**RE: 45 WARRIEWOOD ROAD, WARRIEWOOD FLOOD IMPACT ASSESSMENT –  
RESPONSE TO COUNCIL COMMENTS ON NATURAL ENVIRONMENT (FLOODING)**

We understand that Northern Beaches Council (“Council”) has reviewed the ‘45 Warriewood Road, Warriewood Flood Impact Assessment’ (BMT, 30 September 2020) that was submitted with Development Application DA2020/1517.

Title:  
**Change in Peak Flood Level - 1% AEP Event**  
**+2100 Sea Level Rise +30% Increase in Rainfall Intensity**

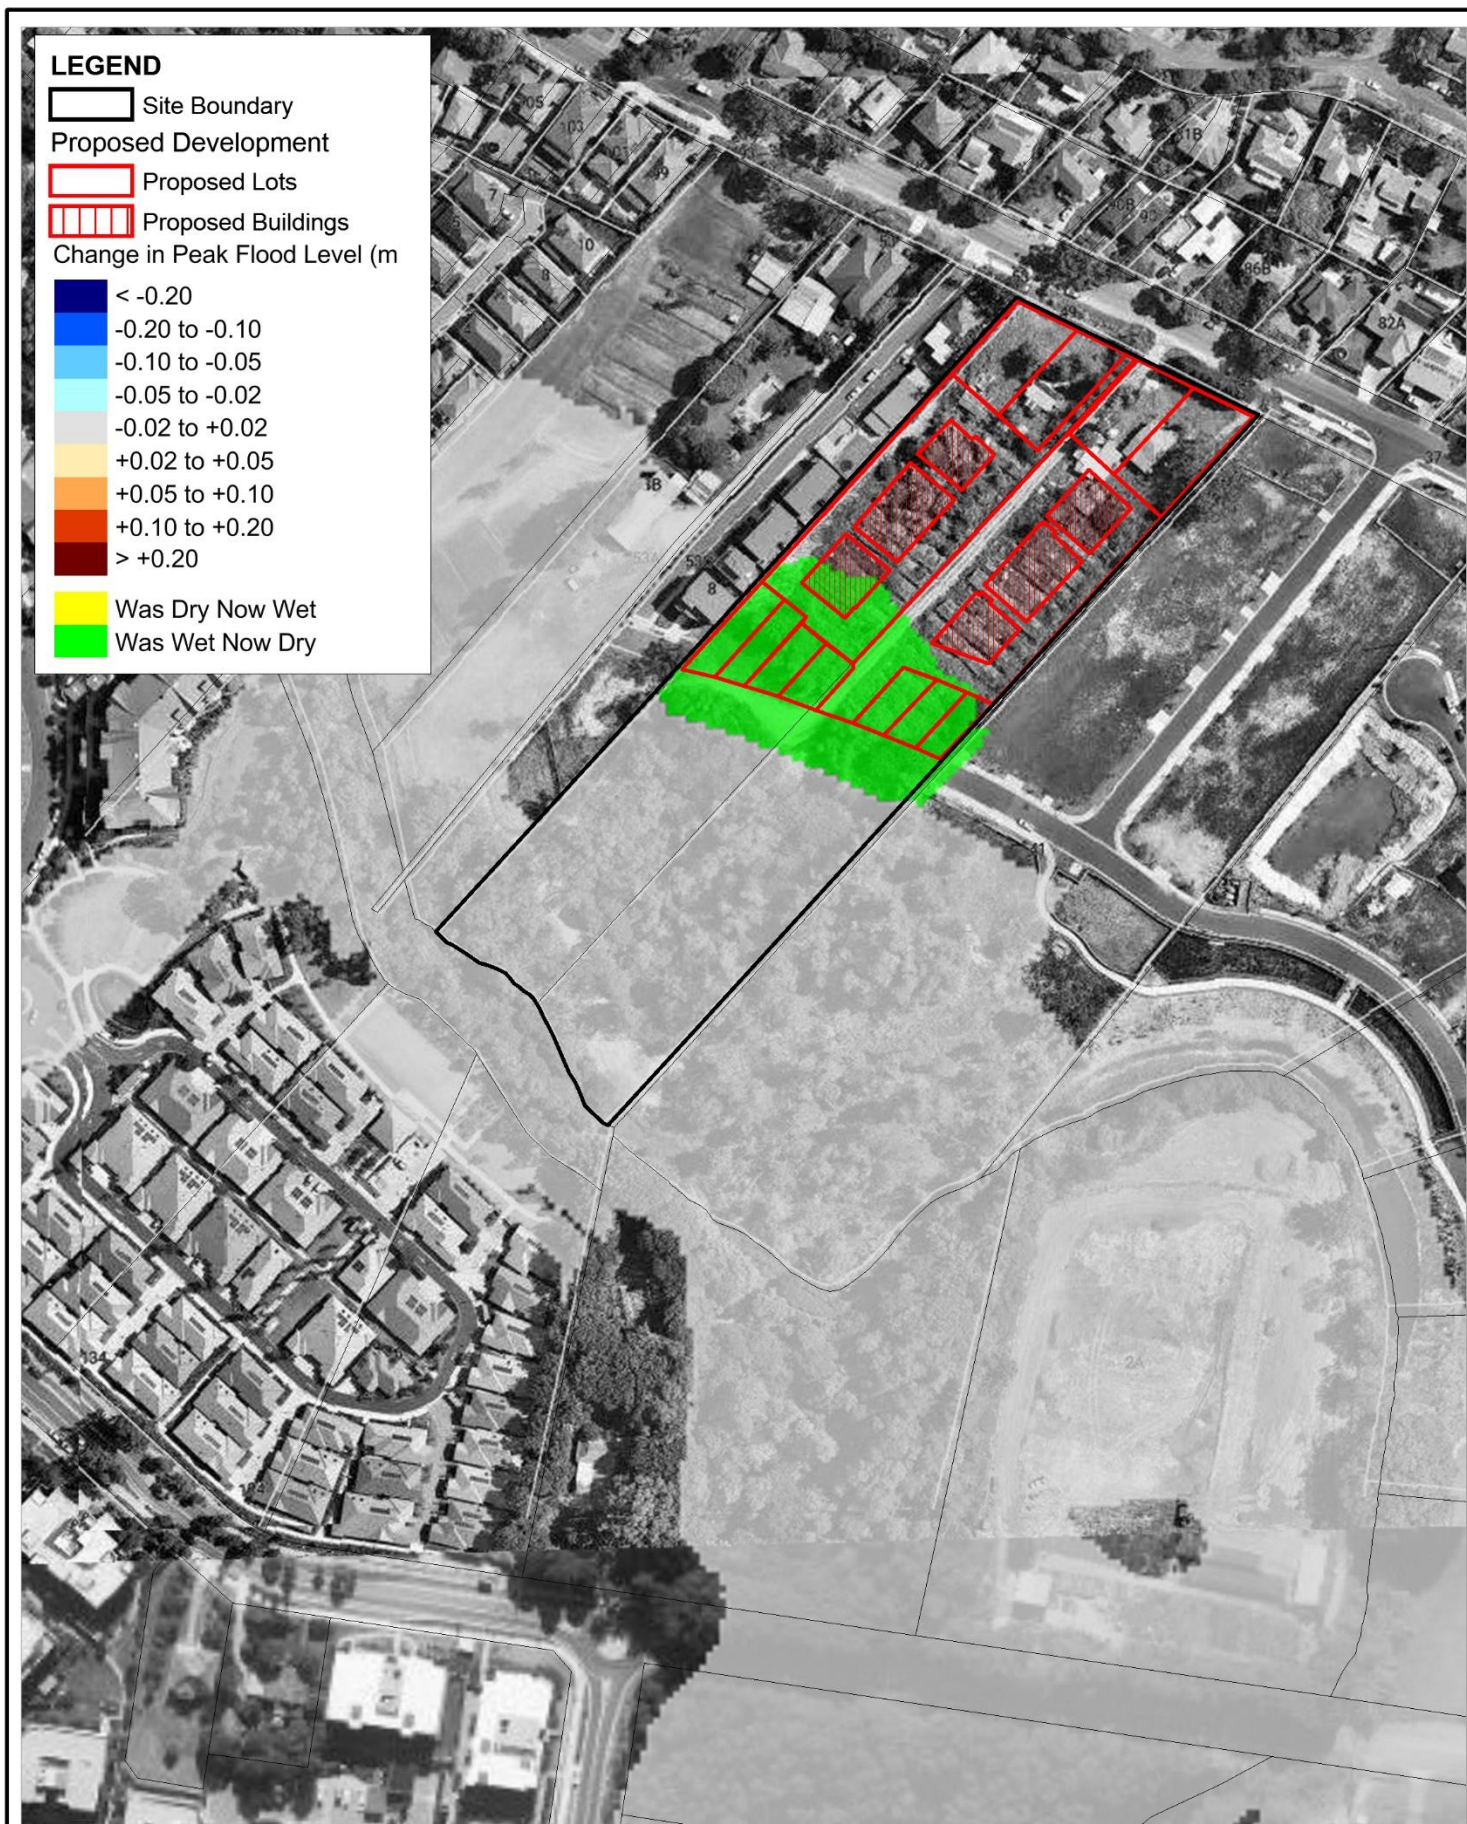
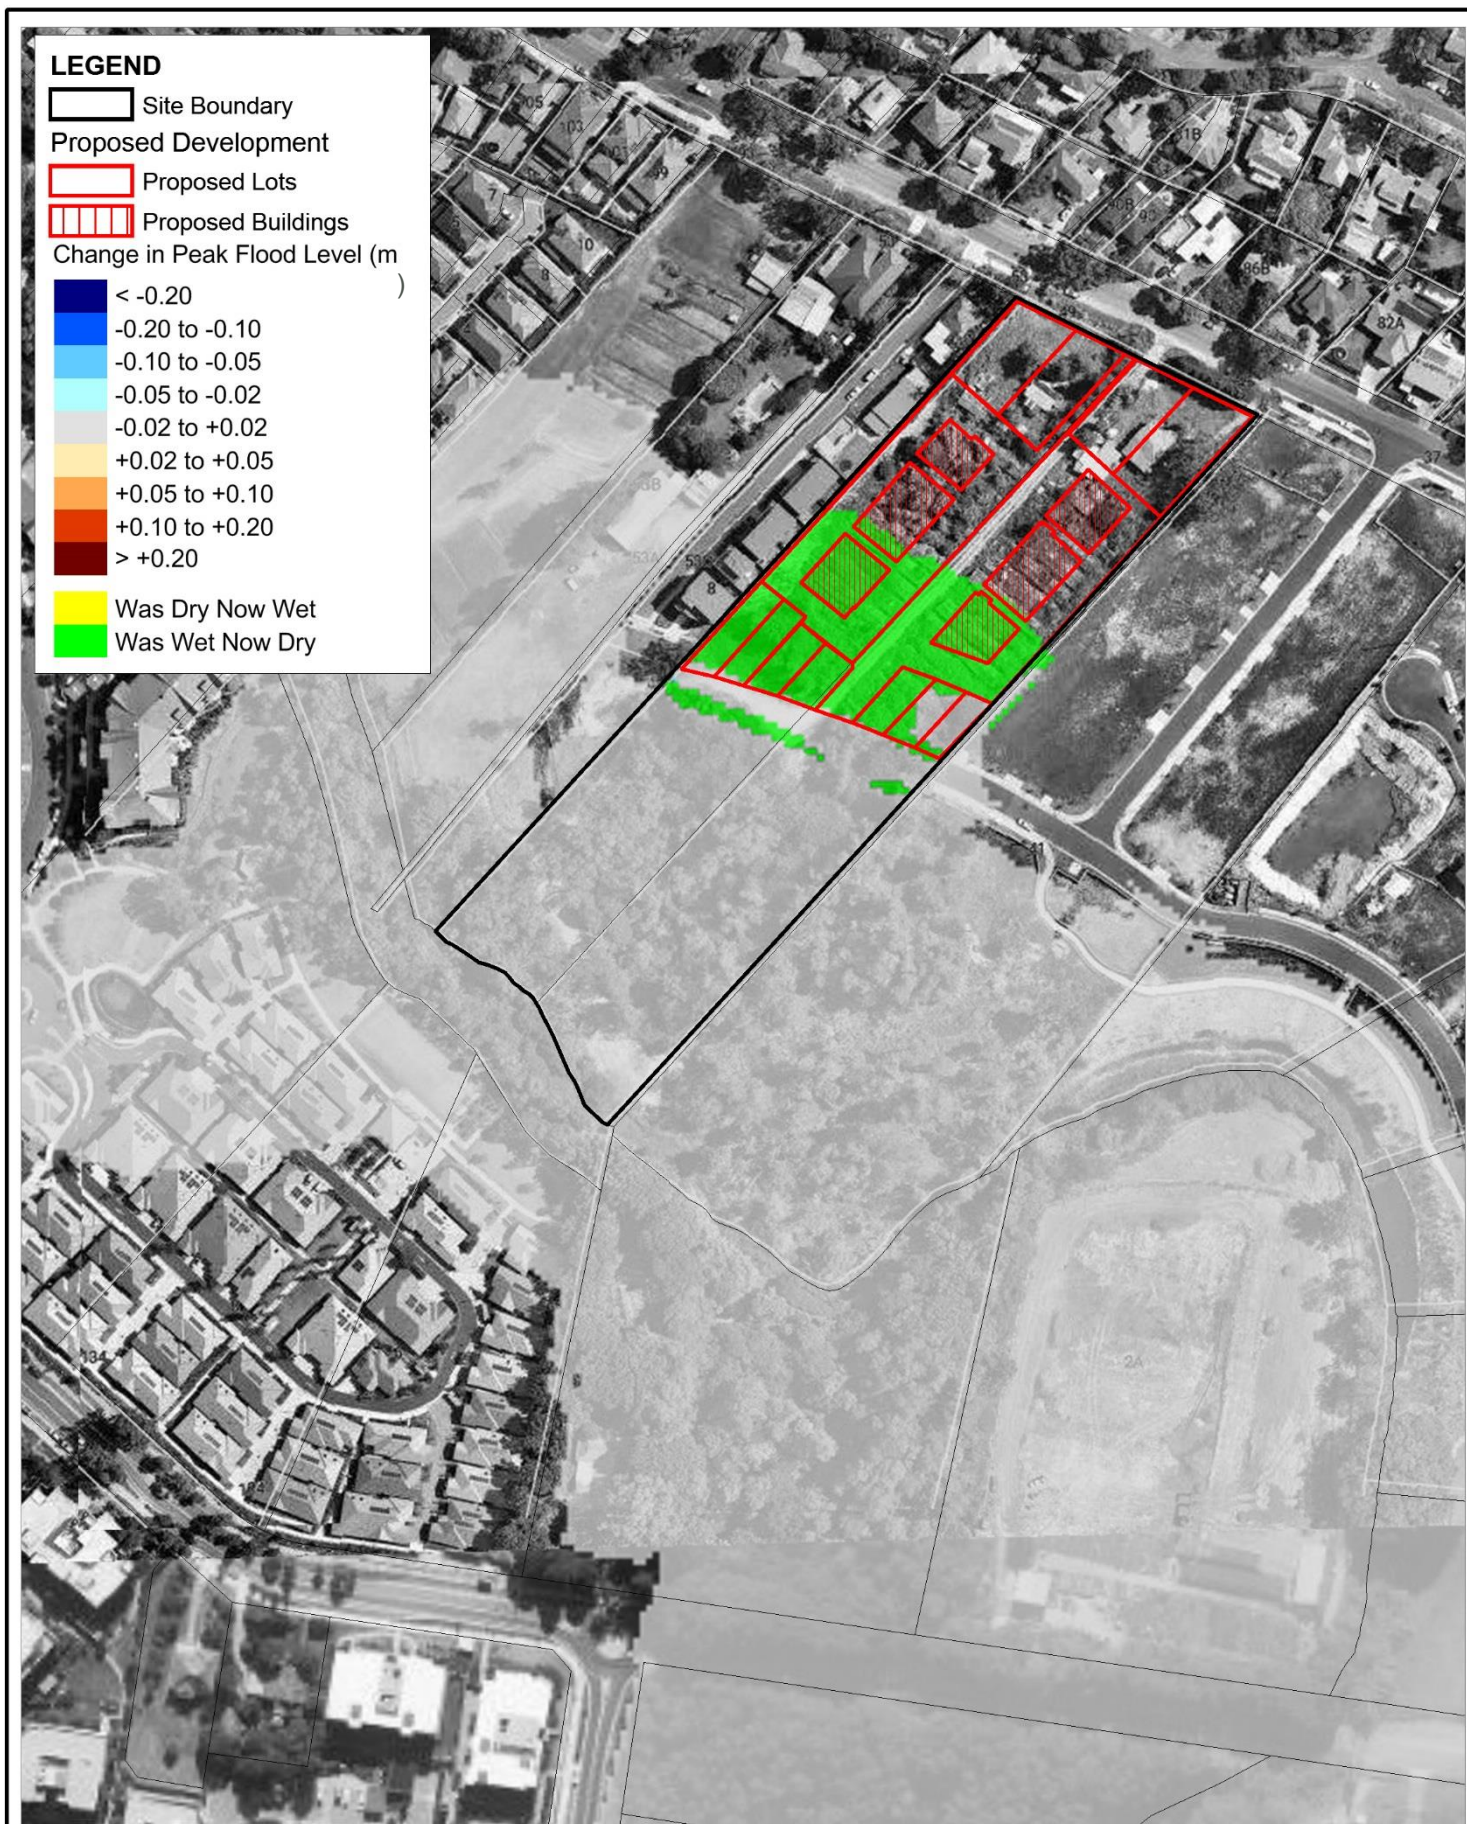
***“Figures 4 and 5 of the Flood Impact Assessment Report prepared by BMT represent the 1% AEP event and the 1% AEP event plus climate change, respectively. However the flood extents appear identical despite Figure 5 representing a larger magnitude flood event. This is inconsistent with Figures B-3 and B-4 which also represent the same flood events. Has the impact of the 1% AEP plus climate change been adequately modelled and represented in the report?”***

The impact of the 1% AEP plus climate change event has been adequately modelled. However, unfortunately there is an error in the mapping shown in the climate change figures included in the ‘45 Warriewood Road, Warriewood Flood Impact Assessment’ (BMT, 30 September 2020).

This mapping has now been checked for all climate change results and rectified, as necessary. Please find attached an updated version of the report that includes this revised mapping.
